LiDAR Quality Assessment Report

KS_Area3-NortheastB_2012

KS_25 COUNTIES LIDAR #1

Lot 6 of 6 lots.

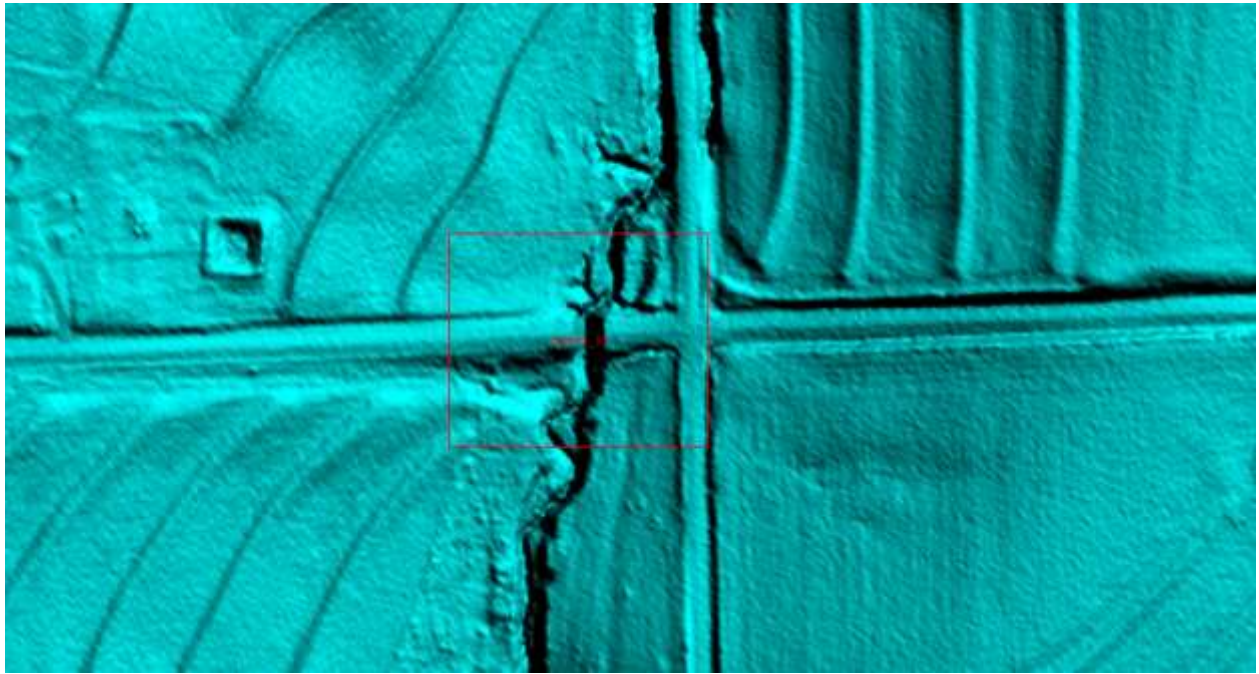
There are several bad tiles that need to be corrected. This is a representative image of this error type. The yellow line delineates tile boundaries. The tile on the left (BE_R055C101) is the bad tile. There are 16 tiles of this error type. They are: BE_R047C102, BE_R047C104, BE_R047C105, BE_R047C106, BE_R048C101, BE_R048C104, BE_R049C108, BE_R050C102, BE_R050C105, BE_R051C103, BE_R054C101, BE_R054C105, BE_R055C101, BE_R055C104, BE_R056C101, BE_R057C101.

****Contractor corrected the tiles****

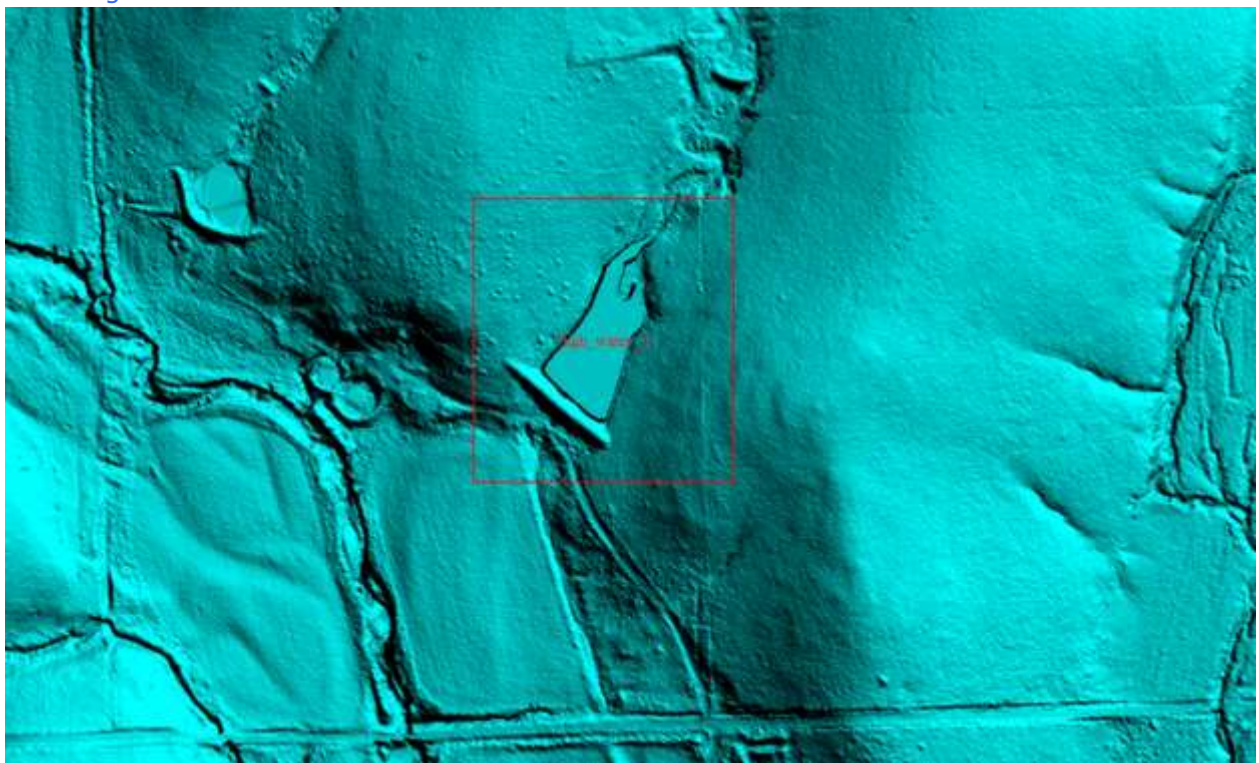
There are several errors in which culverts were removed from the DEM. Roadways over culverts are to be retained in the DEM. There are 104 of this error type.

****All except for one culvert error were corrected****
